**Application for Minor Amendments
to the Building B5 Reserved Matters
Approval 2014/6968/P**

King's Cross Central General Partner Ltd

September 2015

drawing no
EPA KXC 05 300

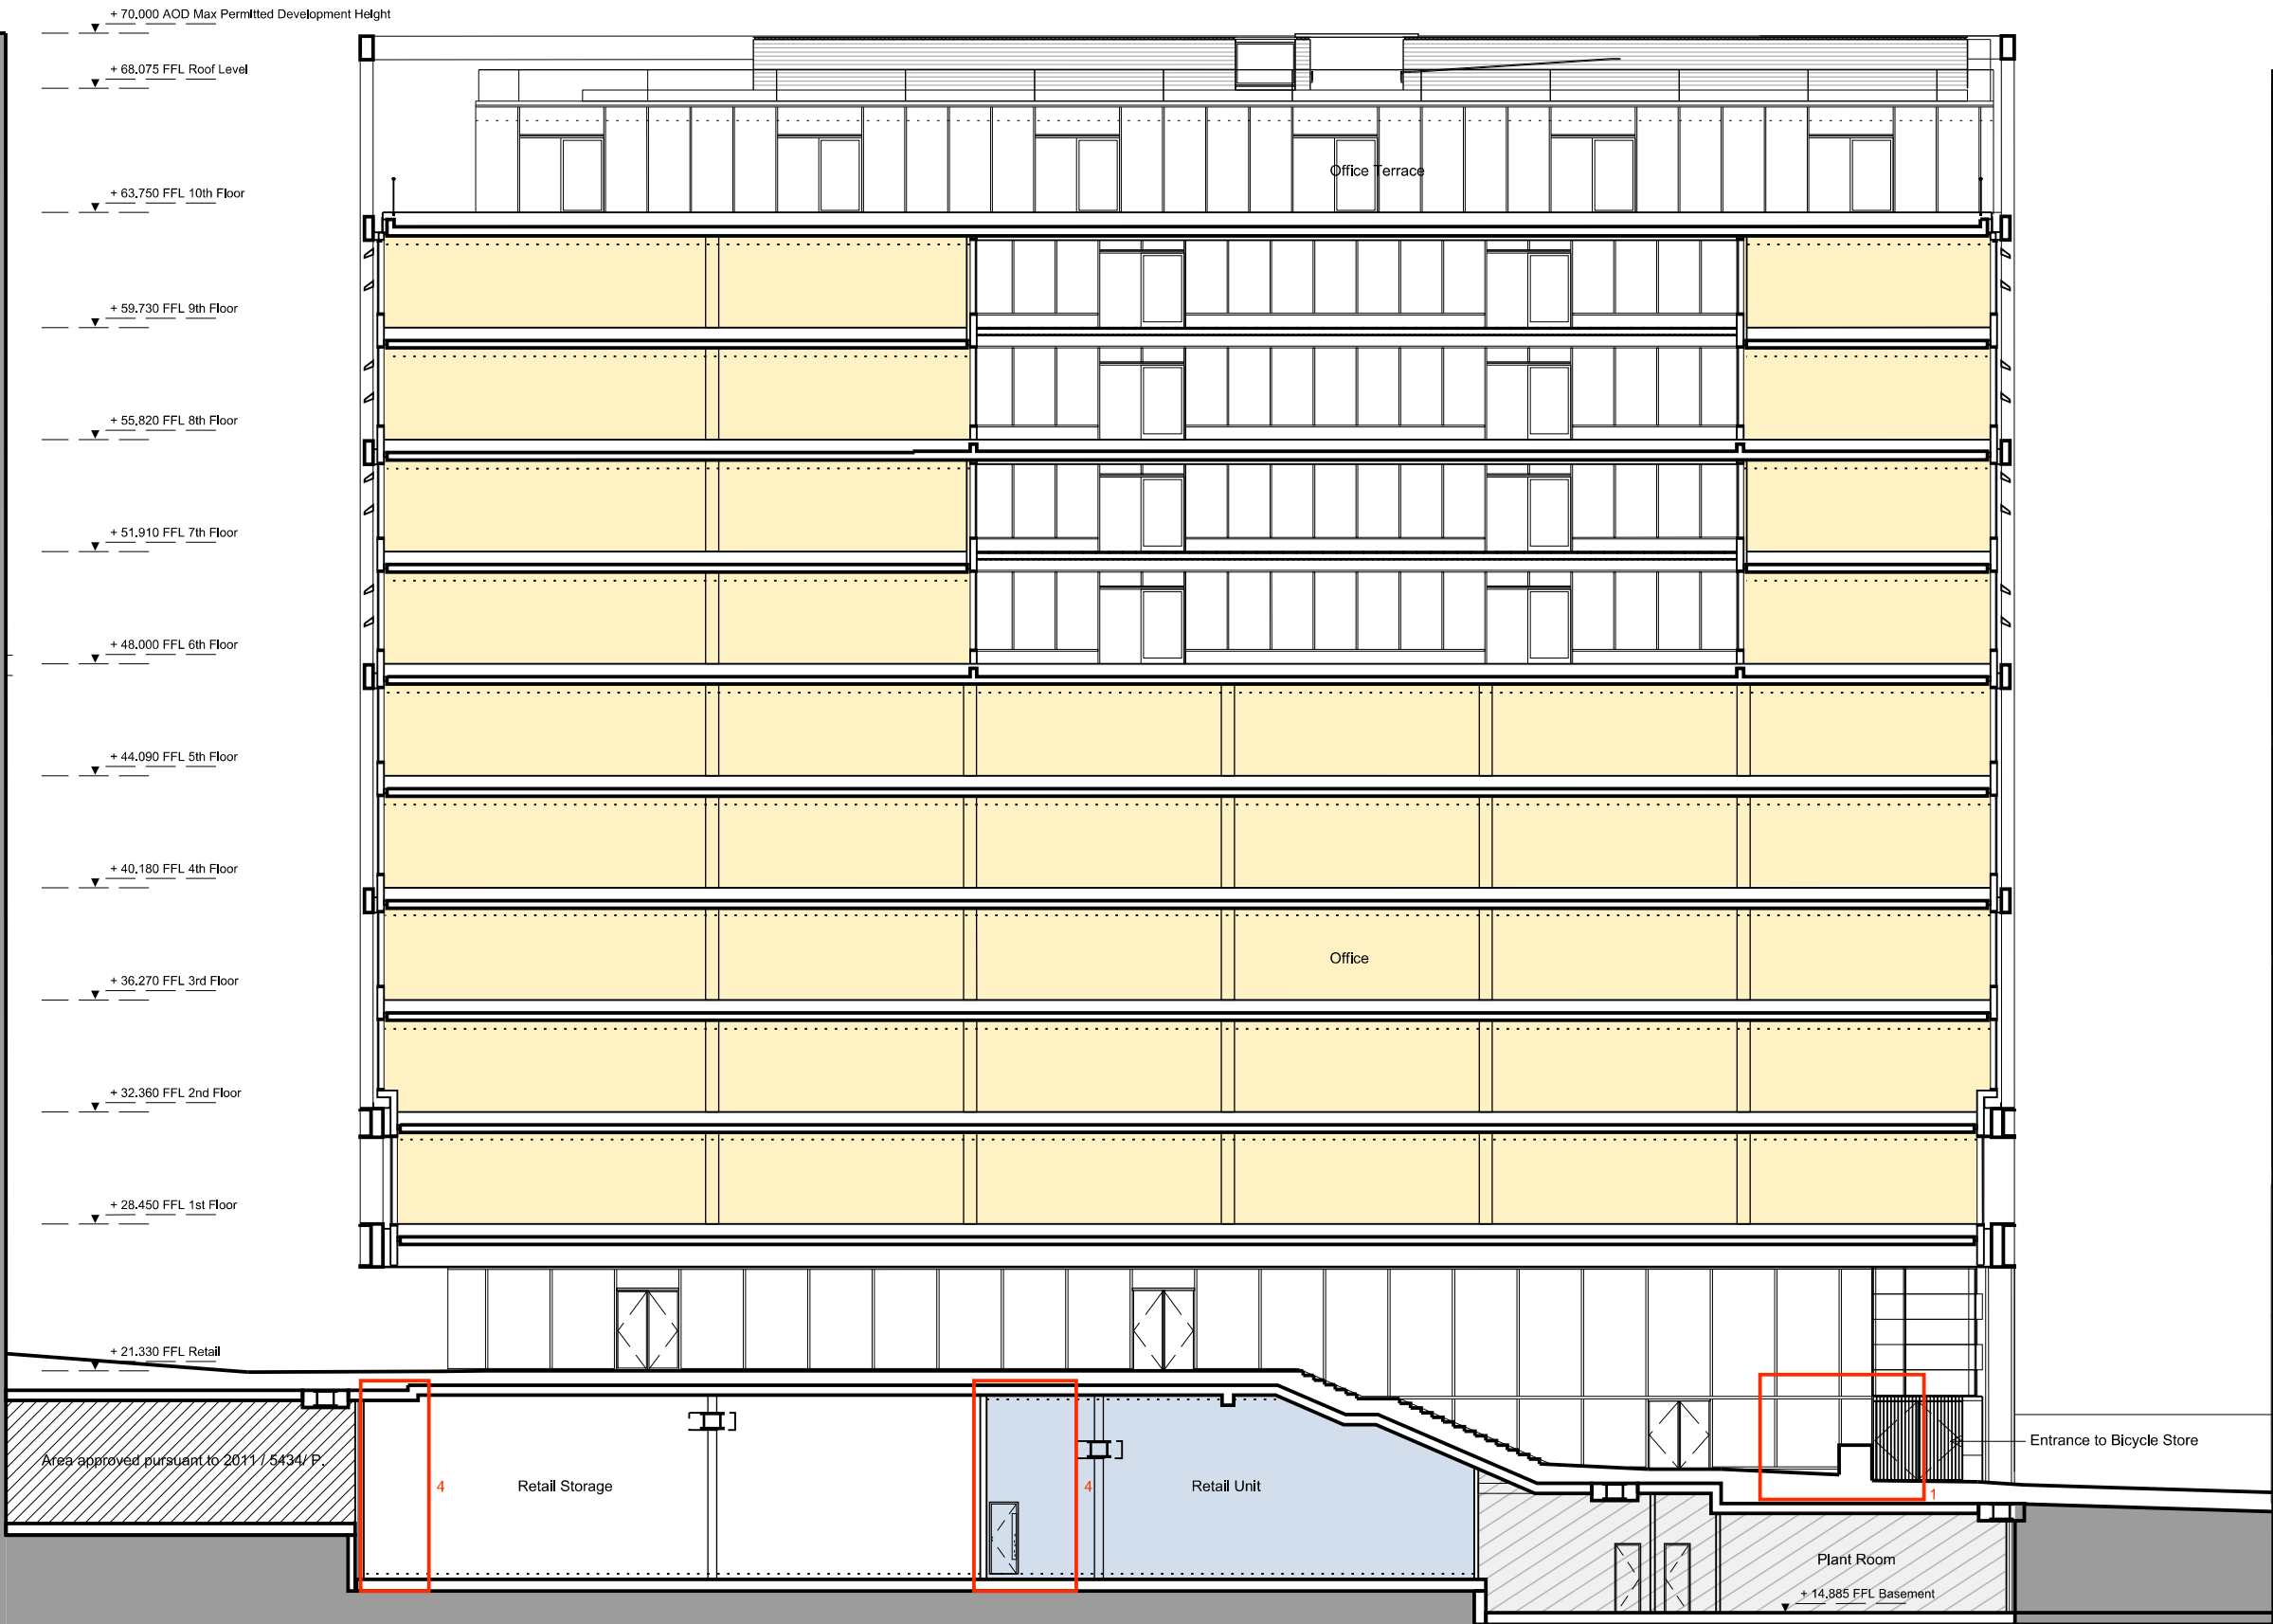
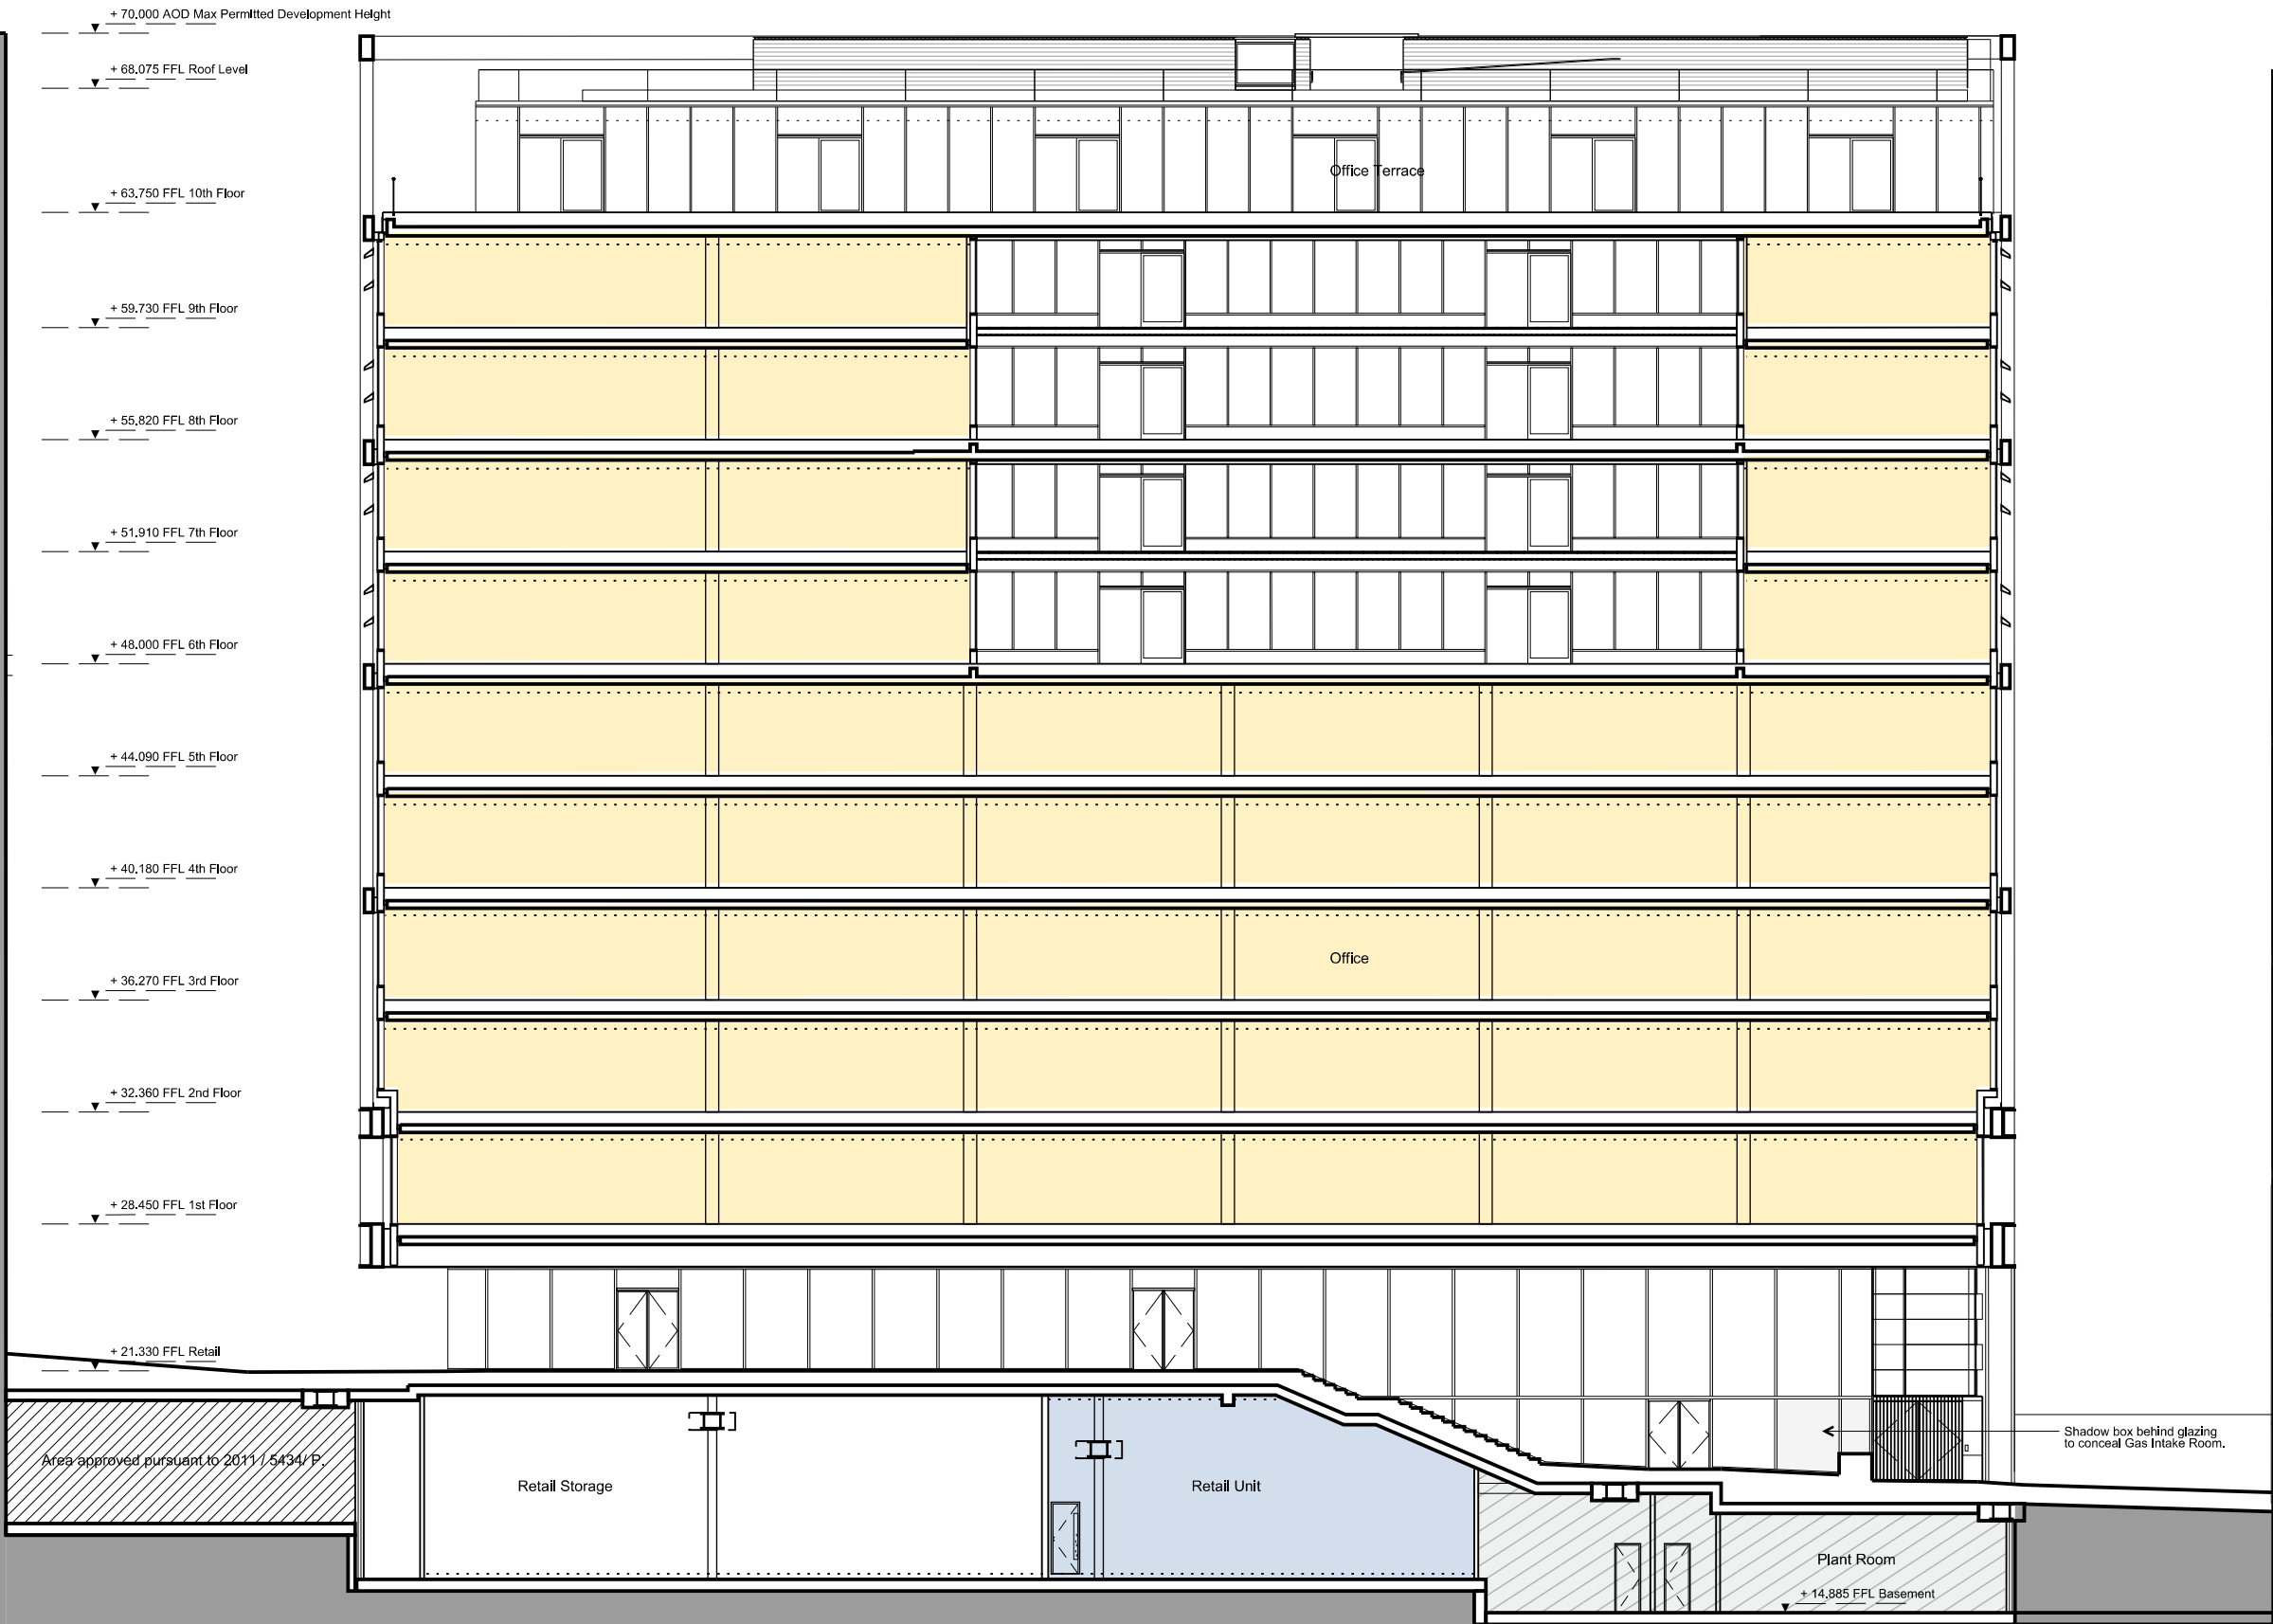
- 2. Gas Intake Room relocated to top of cycle ramp. Louvred doors added to ramp side for access to Gas Room. Mullion and shadow box added to north facade to conceal the Gas Room behind.
- 5. Plant room converted to office space.

P2	Tone added.	27 05 15	MM	RD
P1	Louvre doors added. Plant room decreased in size.	16 02 15	MM	RD
P0	Planning Submission.	29 09 14	JT	RD
Rev	Description	Date	By	Chk

drawing title Proposed GA Tenth Floor Plan	scale 1 : 250 @ A3
drawing no EPA KXC 05 125	revision P1

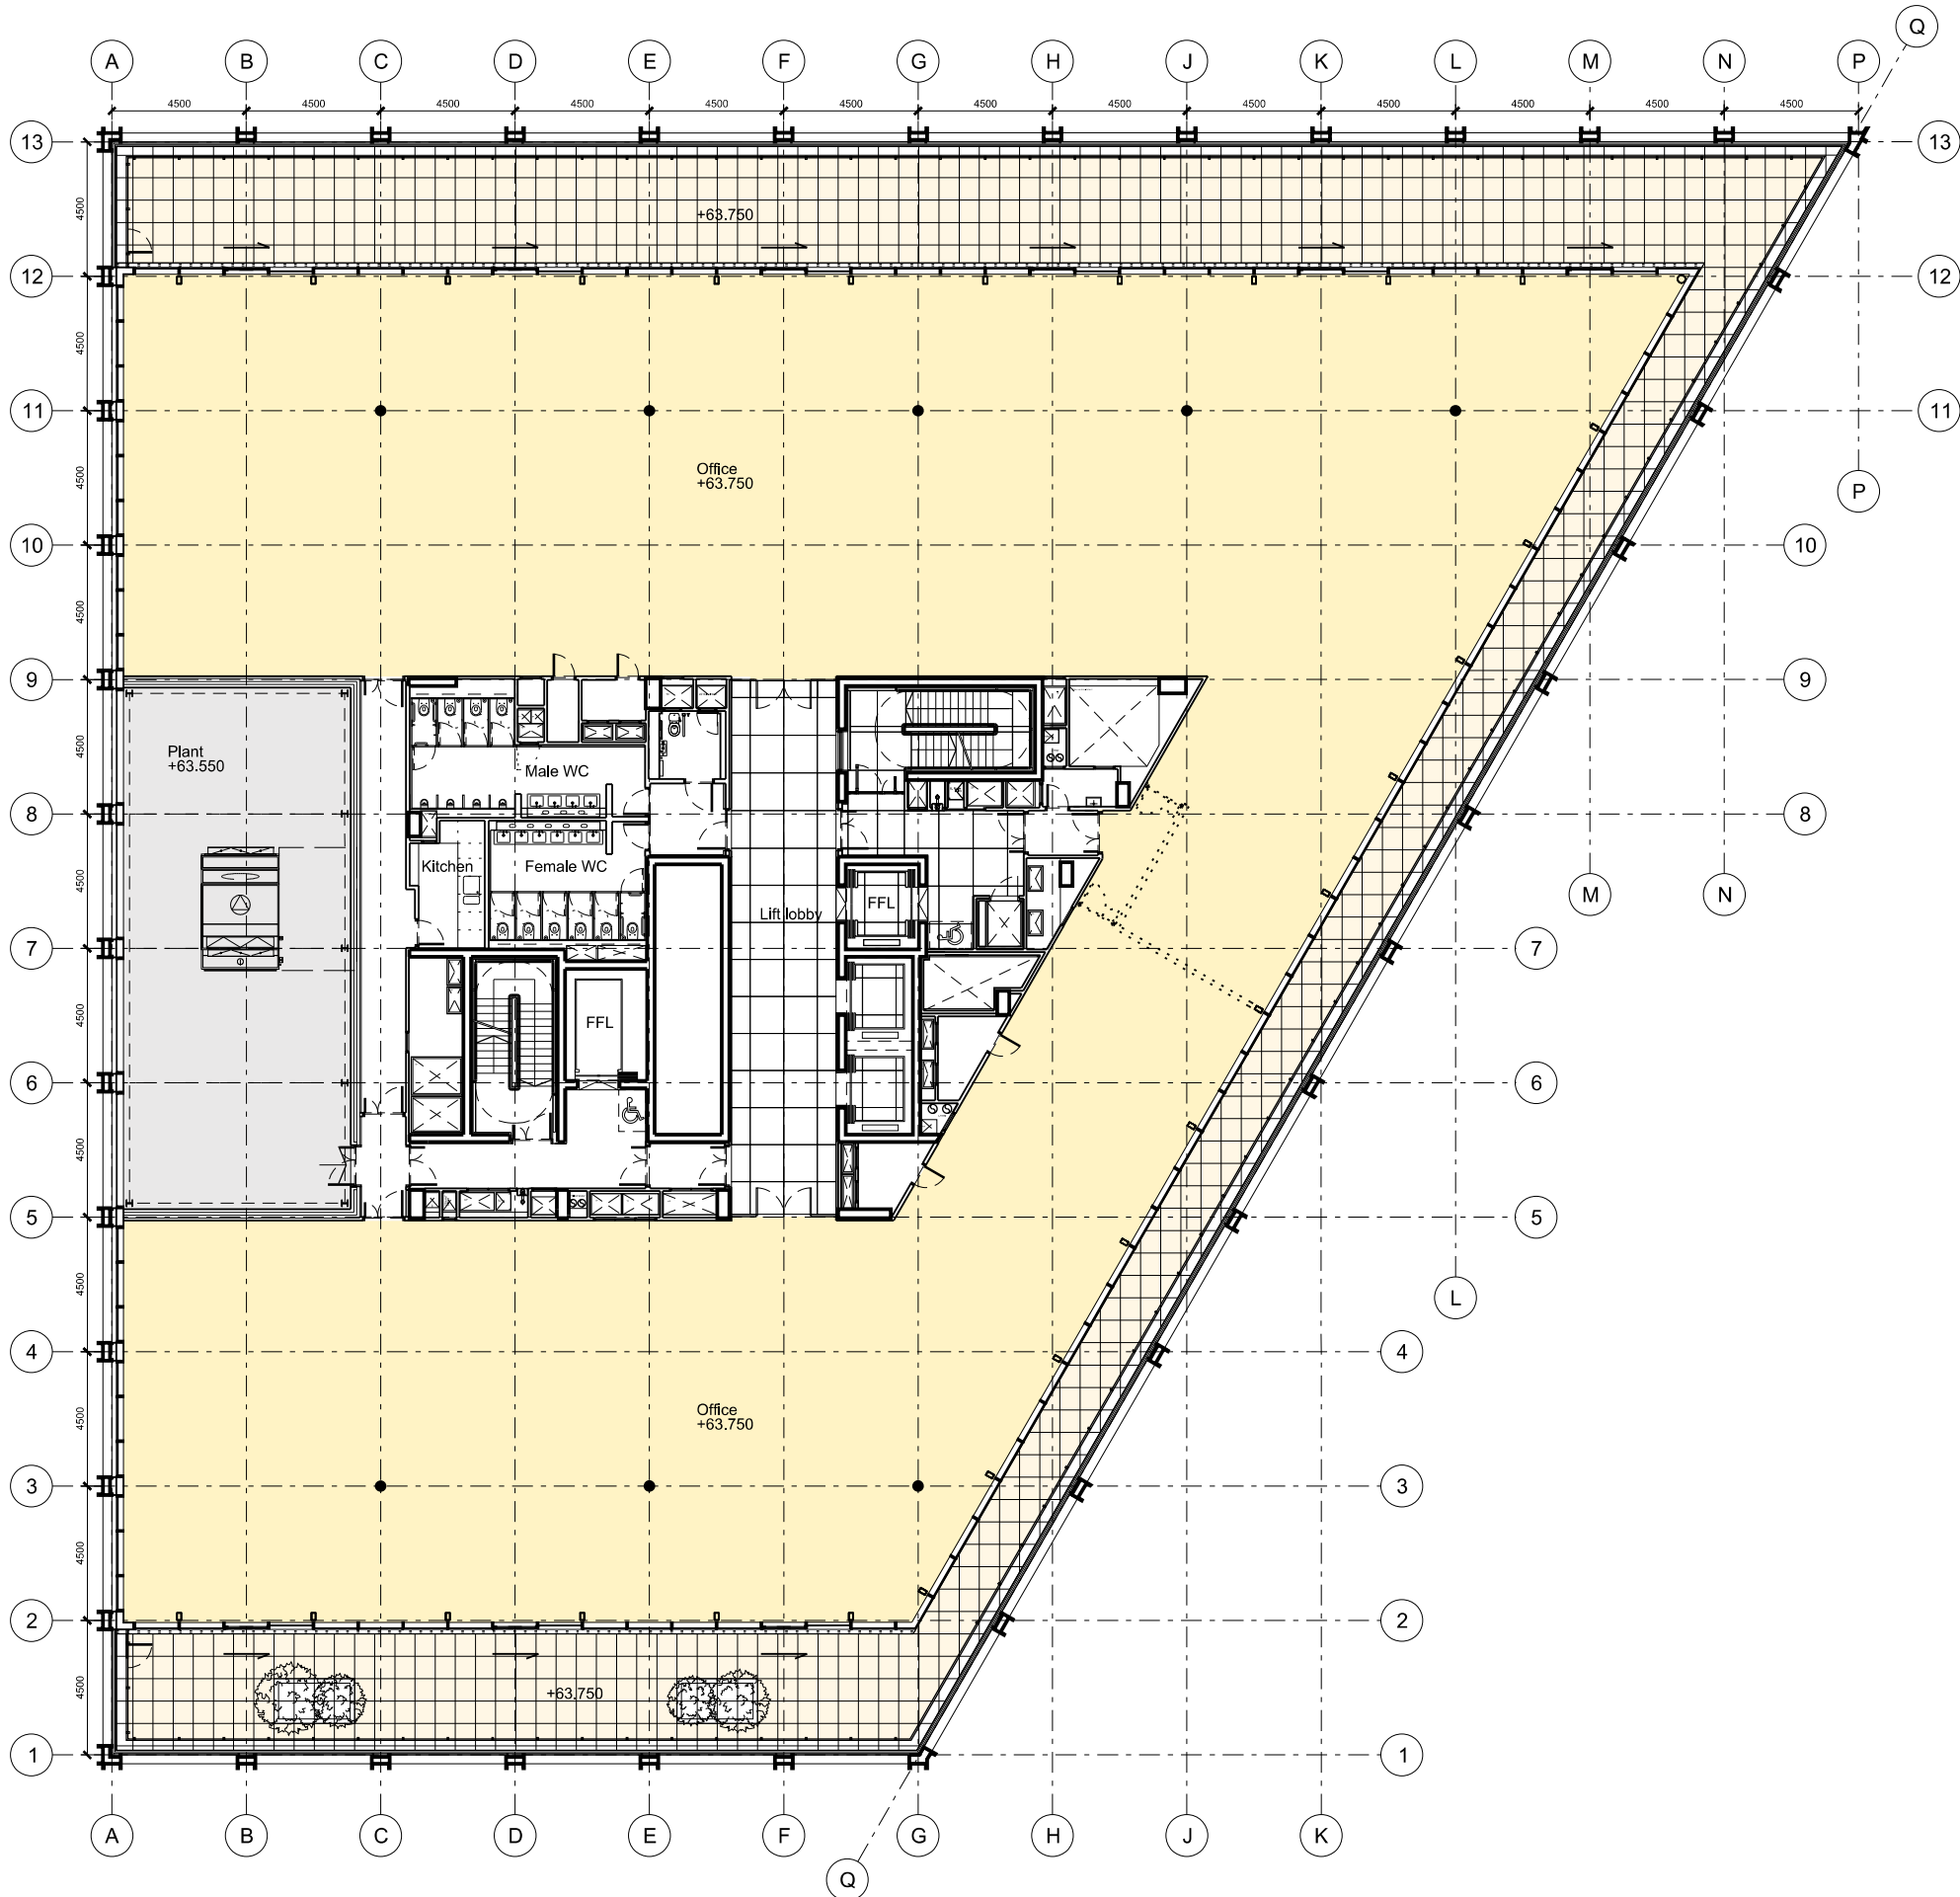
6. Tenth floor plant louvre doors replaced
with fixed louvre panels.

Rev	Description	Date	By	Chk
P3	Tone added.	27.05.15	MM	RD
P2	Lower doors removed.	16.02.15	MM	RD
P1	Sliding doors amended.	16.12.14	RD	RK
P0	Planning Submission.	29.09.14	JT	RD
